REMEDIATION SYSTEM EVALUATION

SMS INSTRUMENTS
DEER PARK, NEW YORK

Report of the Remediation System Evaluation,
Site Visit Conducted at the SMS Instruments Superfund Site
July 16, 2003

EPA 542-R-03-015
December 2003
www.epa.gov/tio
clu-in.org/optimization

FIGURE 1-2. THE FORMER SMS INSTRUMENTS FACILITY, SURROUNDING AREA, AND WELL LOCATIONS.

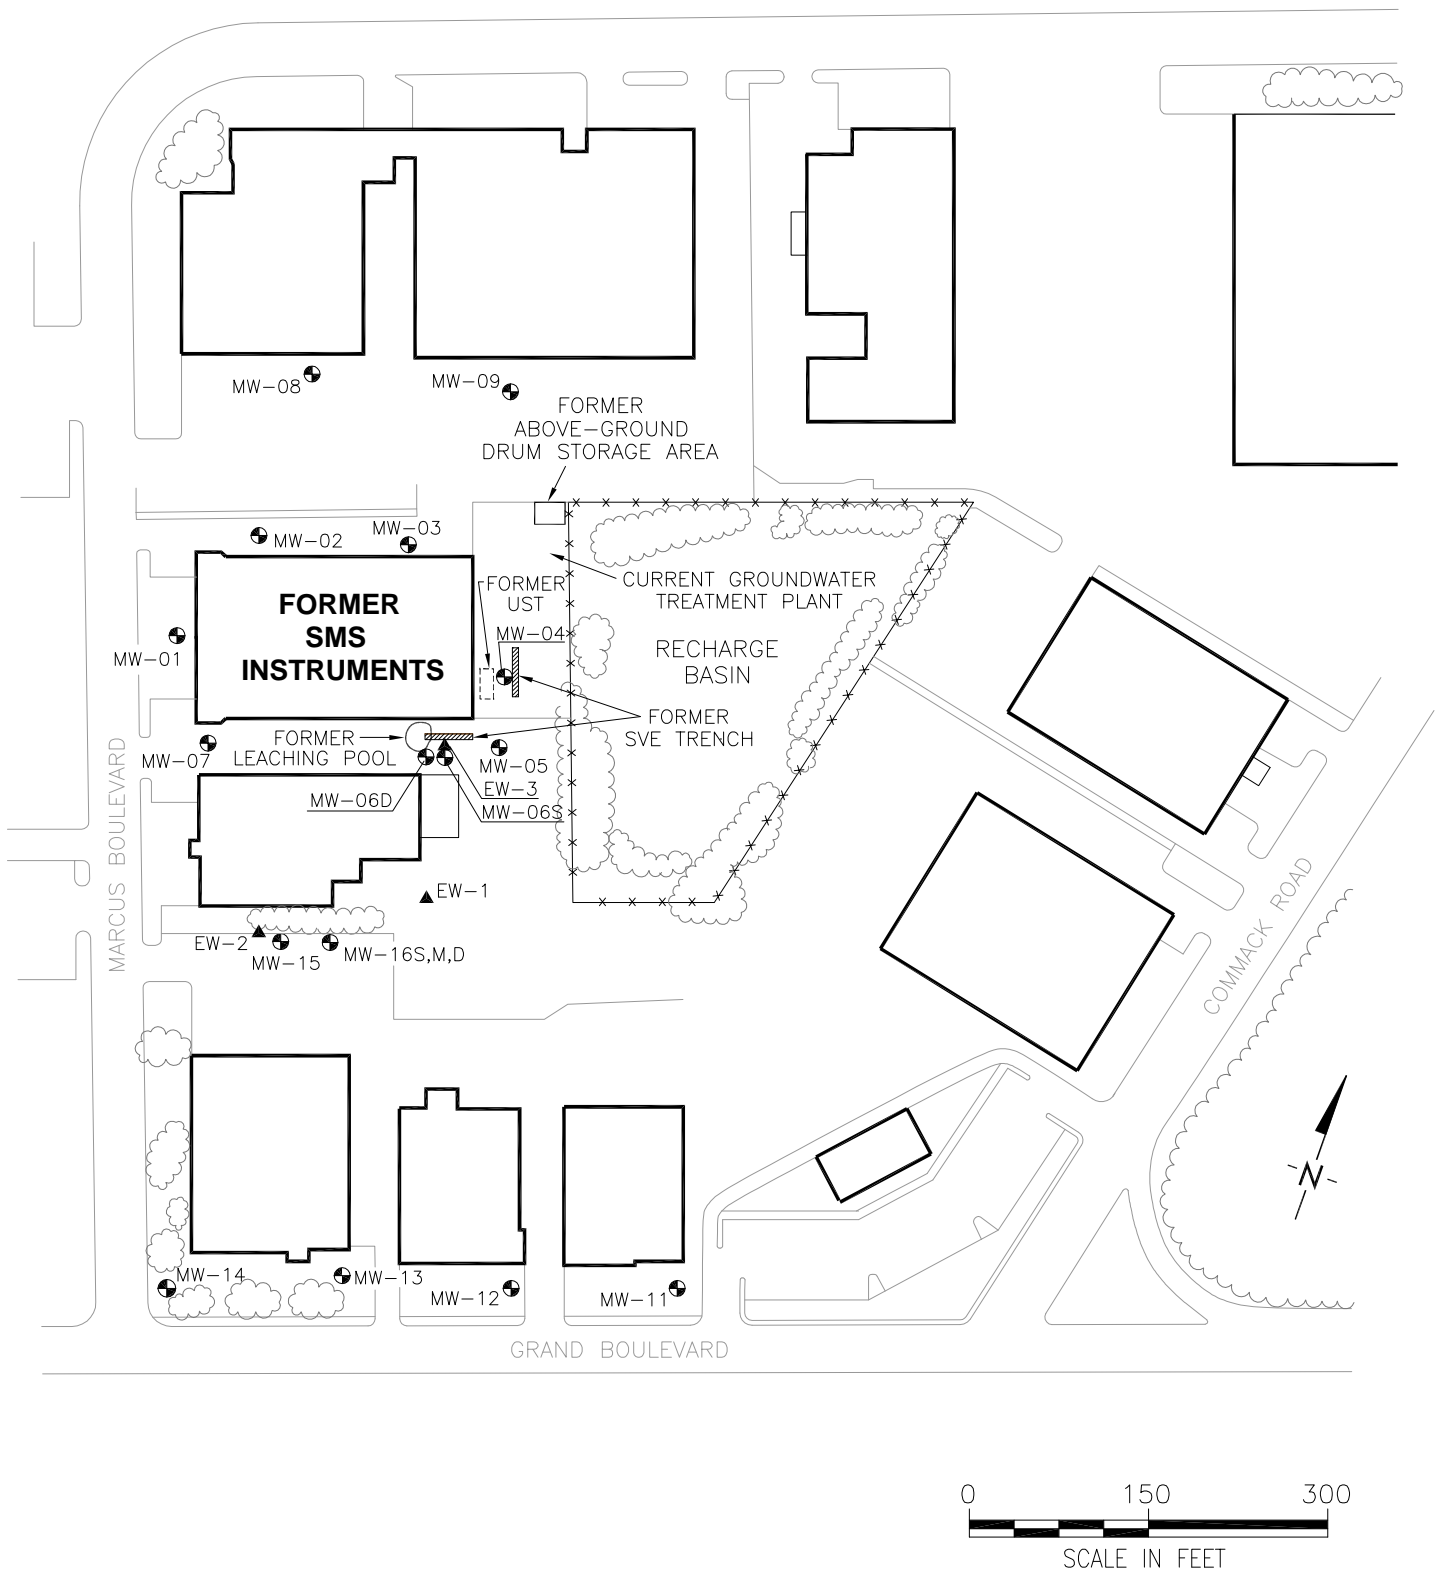
Figure 1-2 presents the locations of these wells and shows that MW-6S and EW-3 are located adjacent to each other in the area of the former leaching pond. No monitoring points are located between this area and EW-1, but given the continued contamination at EW-1, it is likely that this intermediate area has contamination above cleanup standards.

FIGURE 4-1. VOC CONCENTRATION TREND IN MW-6S

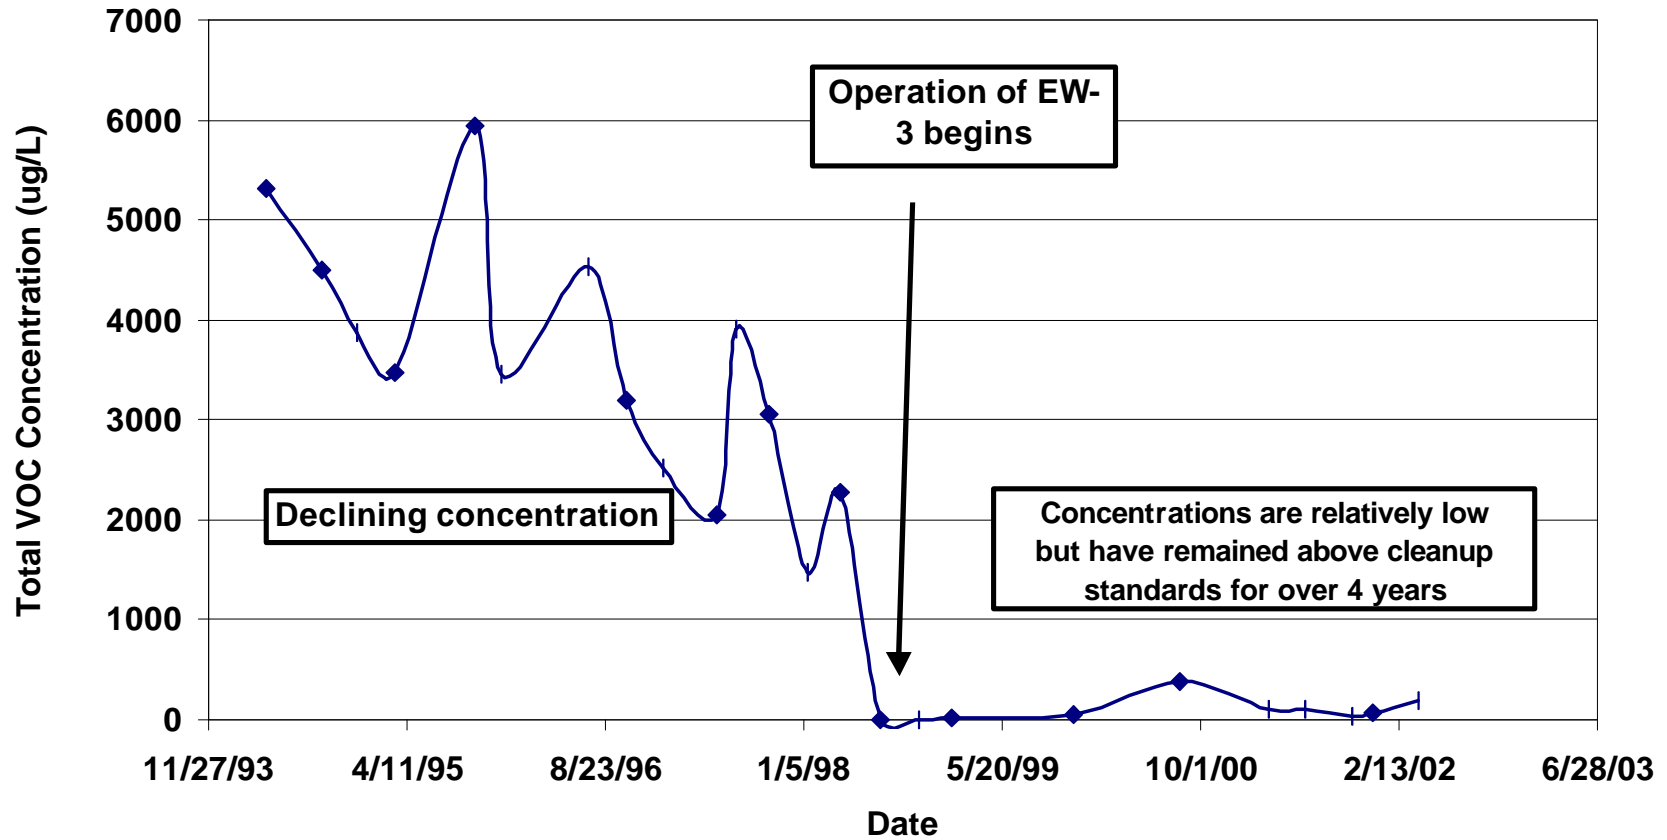
The VOC concentration in MW-6S (source area) declined between 1994 and 1998 due to the natural flushing of clean water through the site. EW-1, located at the downgradient boundary of the site, was installed to capture contamination before it moved offsite. The 1998 installation of EW-3 in the source area accelerated aquifer restoration. Concentrations are orders of magnitude lower than during the original investigations; however, they have remained consistently above cleanup standards. Data collected in sampling events since April 2002 have not been processed or reported as of July 2003.
